**ADDENDUM TO BID
PARKING LOT T DEMOLITION
BID NO.: 914-PW-132**

ADDENDUM NO.: 1

PARKING LOT T DEMOLITION

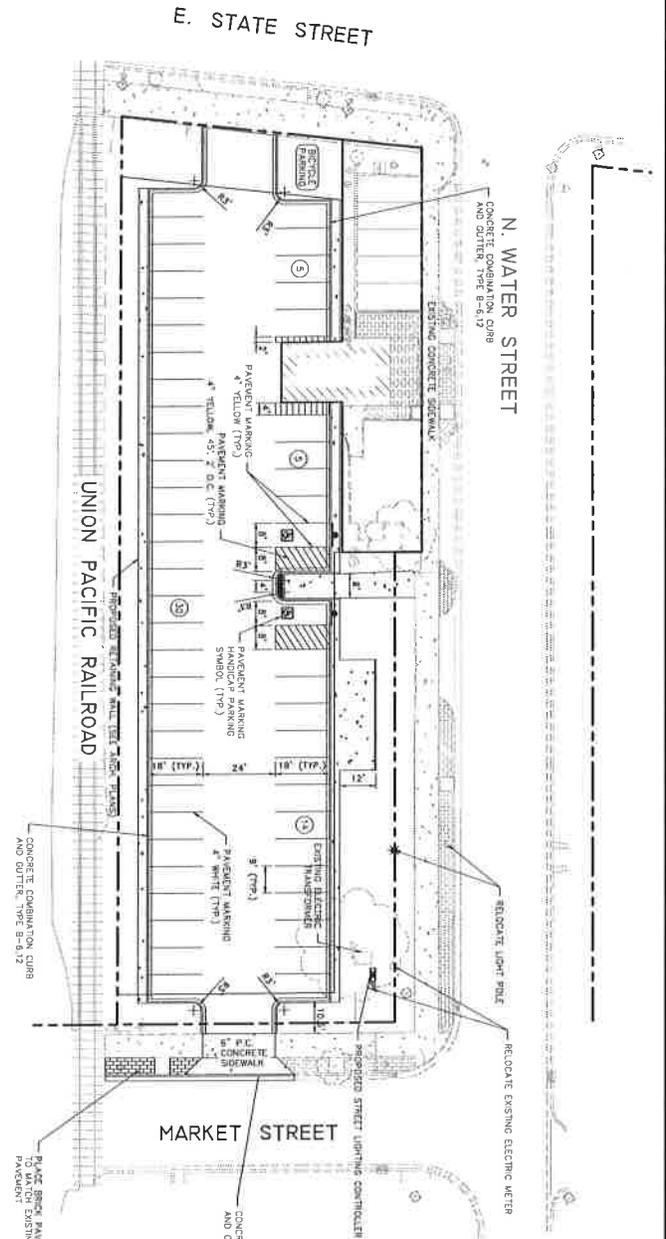
1. Future phases of demolition and proposed items have been faded and/or omitted from the plans. For further clarification, please see the PHASE WORK notes on the plans and special provisions.
2. Proposed parking lot has expanded to the north and south to accommodate a total of 4 additional parking spaces.
3. Polymerized asphalt mix has been modified to the following binder course:
 - a. 2" HOT-MIX ASPHALT BINDER COURSE, IL-19.0, N50
4. The following note has been added to the GRADING NOTES on the GRADING PLAN:
 - a. 13. PROPOSED ELEVATIONS ARE SHOWN TO PAVEMENT SURFACE COURSE GRADES. CONTRACTOR SHALL CALCULATE FINAL GRADES FOR PAVEMENT BINDER COURSE ELEVATIONS. DRAINAGE STRUCTURE LID ELEVATIONS SHALL BE ADJUSTED TO BINDER COURSE ELEVATIONS.

7. Contractor Question: "Sheet #2 Site Plan shows a light pole being relocated (NW side of the building). I would assume this would be part of this contract as we have to tie the South Side Street Lighting into the new lighting controller?"

12. Contractor Question: "Sheet #2 Site Plan shows the existing meter to be relocated. (I believe this is fed for the lighting controller for the lighting North of Market Street). This meter is to be relocated. Is this the meter shown on sheet E1.1 by the future panel and timeclock? (Looks like this is a new meter for the future bid package for this project). If not where is this stand-alone meter to be relocated to? "

Response: Yes- the relocation of the light pole along Water Street is included in this contract since it is tied to the new lighting controller.

Response: See the revised Sheet #2 Site Plan for the relocation of the existing meter for the north portion of Water Street.

DATE:	7.10.14	ISSUED FOR:	DATE
PROJECT NUMBER:	24085	DRAWN & CHECKED:	J. COOPER
SHEET NUMBER:	C1.1	APPROVAL #1:	9.31.2014
		DRAWN:	APPROVED:
		AM	AM

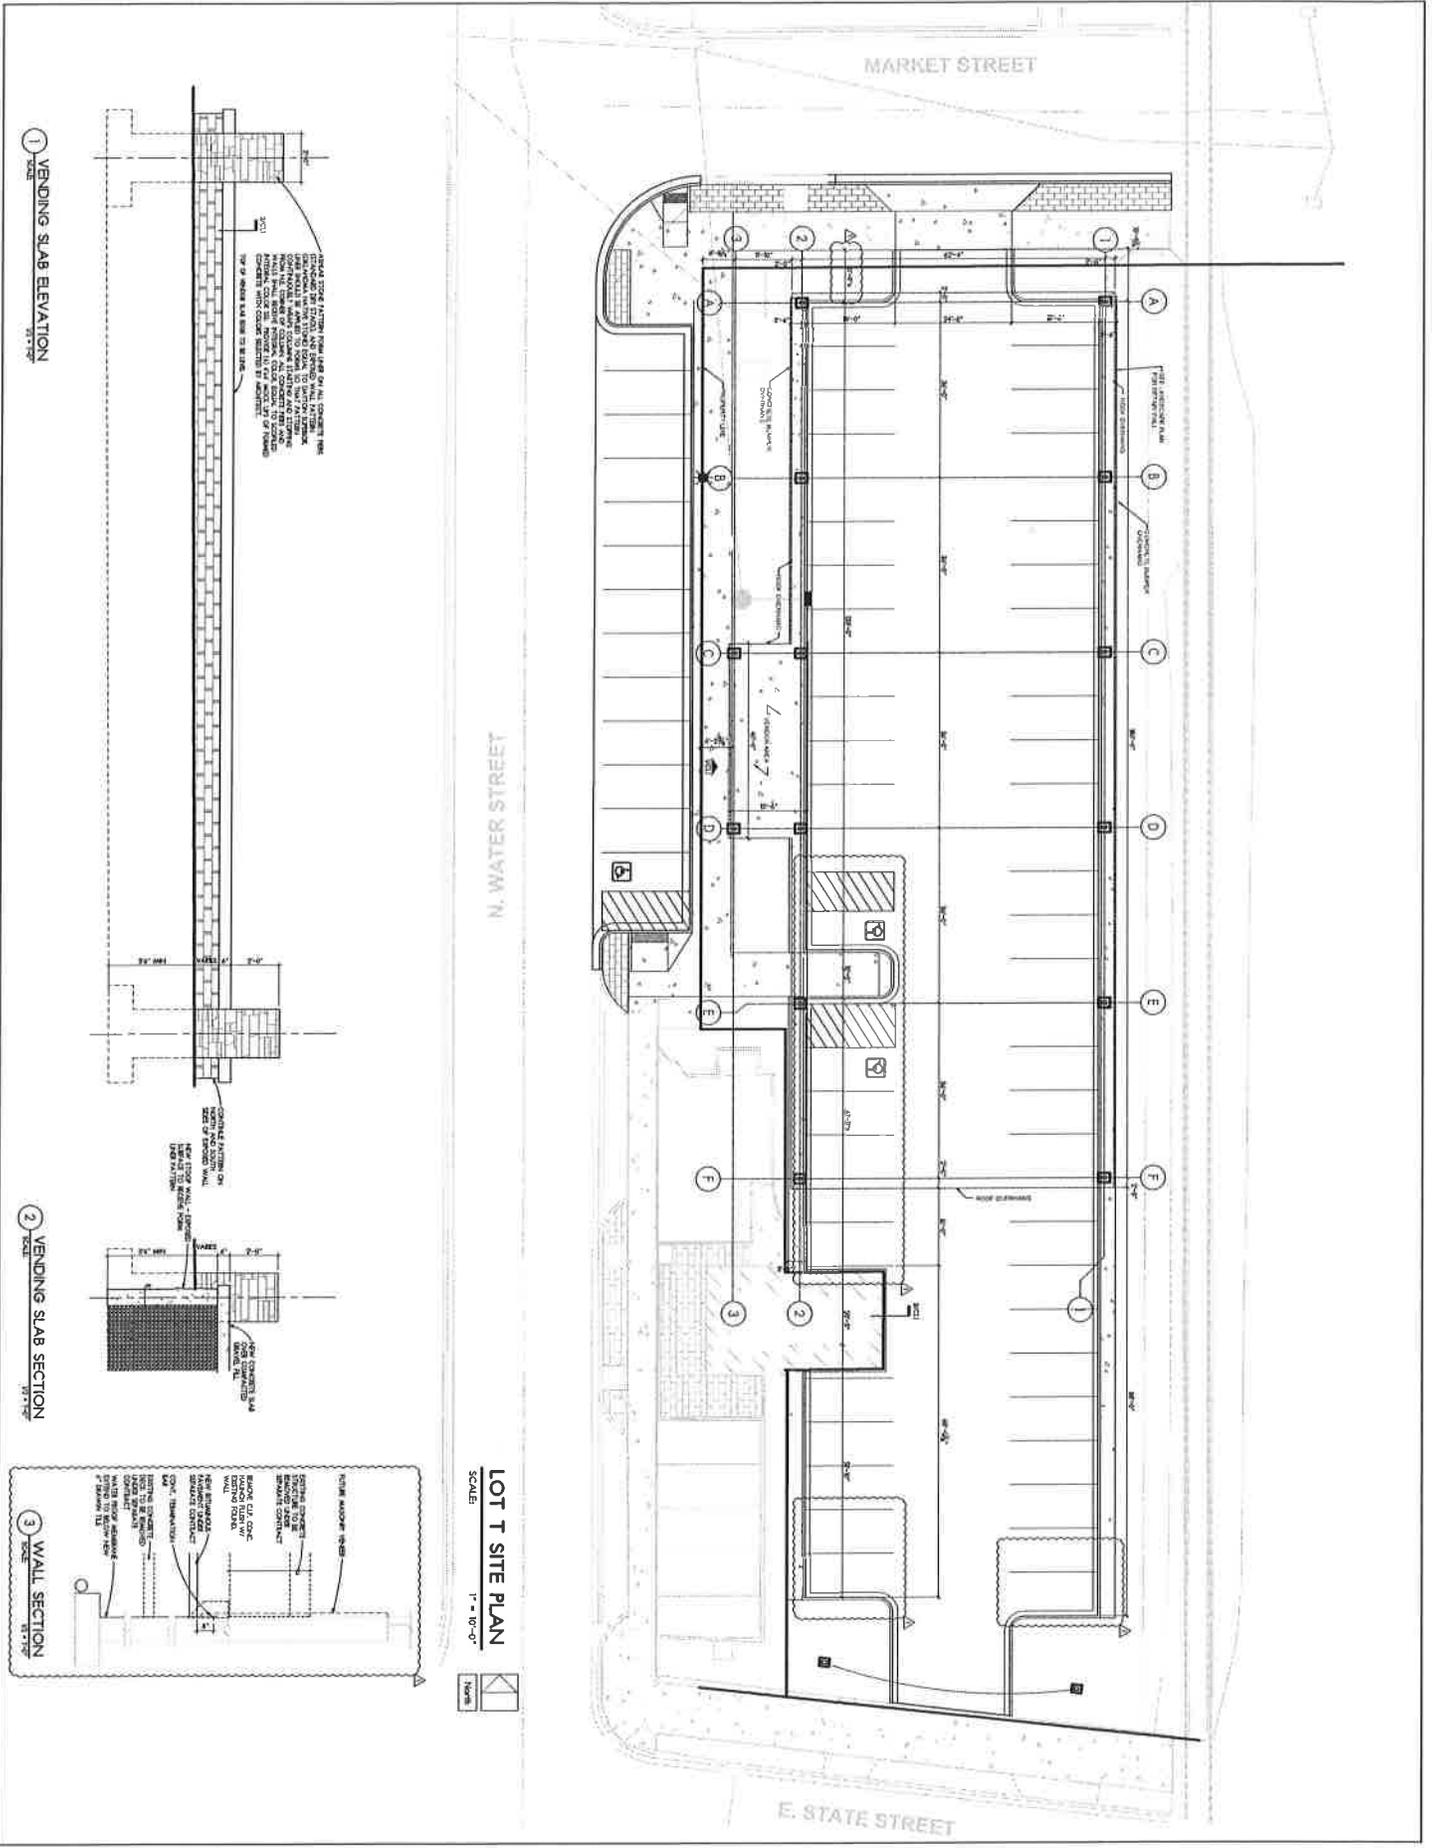
2. All sheets: Parking lot configuration was updated to match Civil drawings for the addition of new stalls
3. C1.1: Detail 3 was added to show typical waterproofing on café foundation walls below grade.
4. C1.1 : Bike racks were omitted from the plan. Intended to be part of the next phase.
5. S1.1 : top of footing elevations were added with notes for coordination and minimum bearing conditions.
6. S1.1: Added note on concrete design.
7. Segmental Block Retaining Wall: Overall length increased from 196 LF to 208 LF.
8. Segmental Block Retaining Wall: Overall area increased from 415 FF to 480 FF.
9. Segmental Block Retaining Wall: Bottom of Wall (BW) elevation changes throughout.

4. Contractor Question: "Architectural sheet C1.1 (Larson & Darby plan) shows colored, patterned concrete for columns at vending slab and also the stoop wall. Is this required for all column piers on the project?"

Response: Yes- all column piers on the project shall match the colored patterned concrete.

DATE: 7.30.14
PROJECT NUMBER: 24085
SHEET NUMBER: S1.1

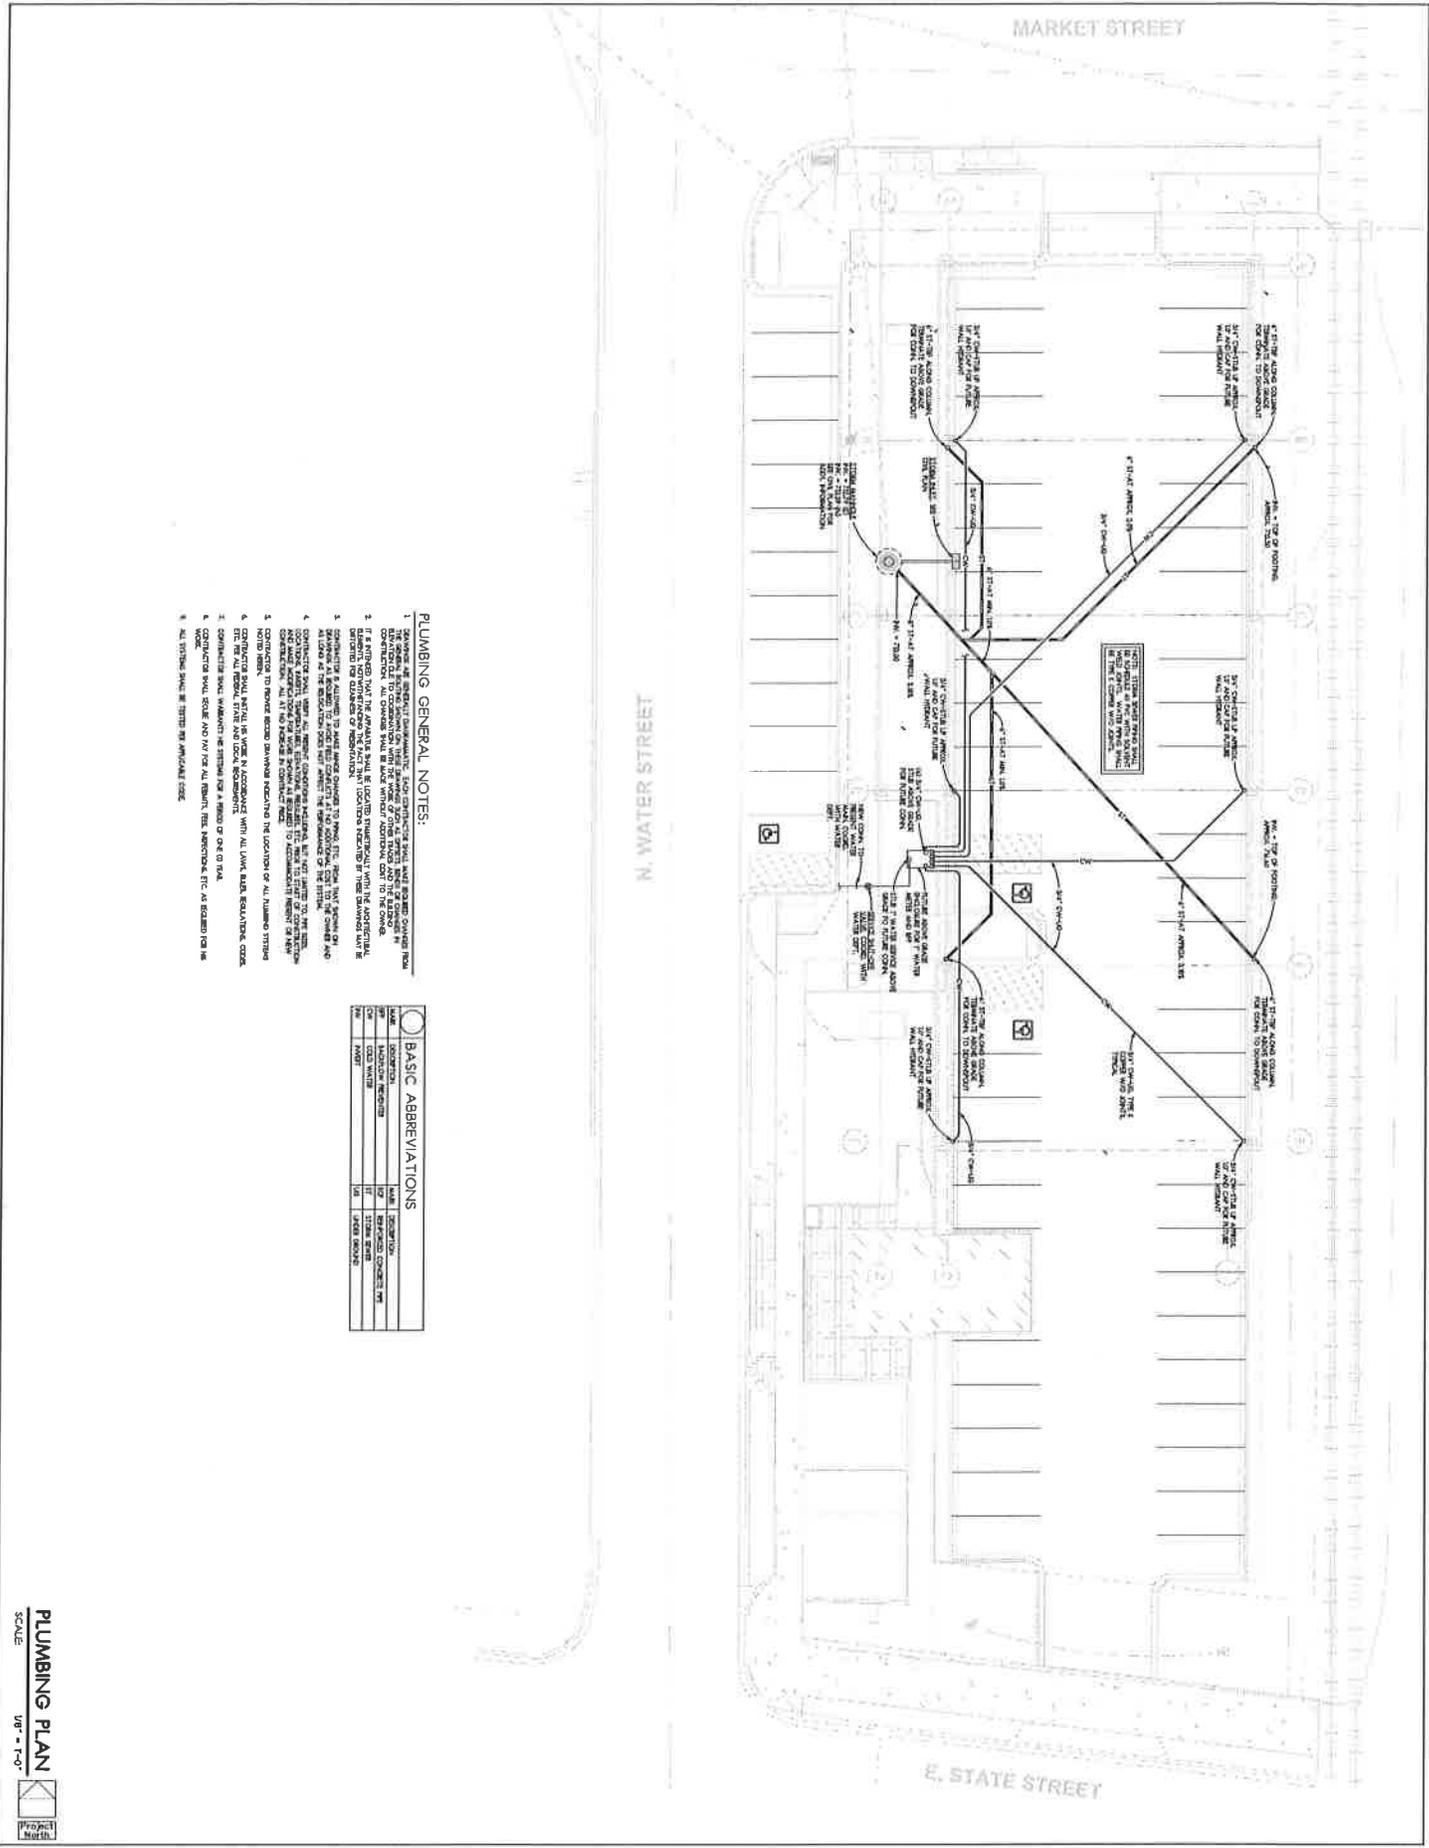
1. All sheets: Column footings have moved 5'-0" toward project North.
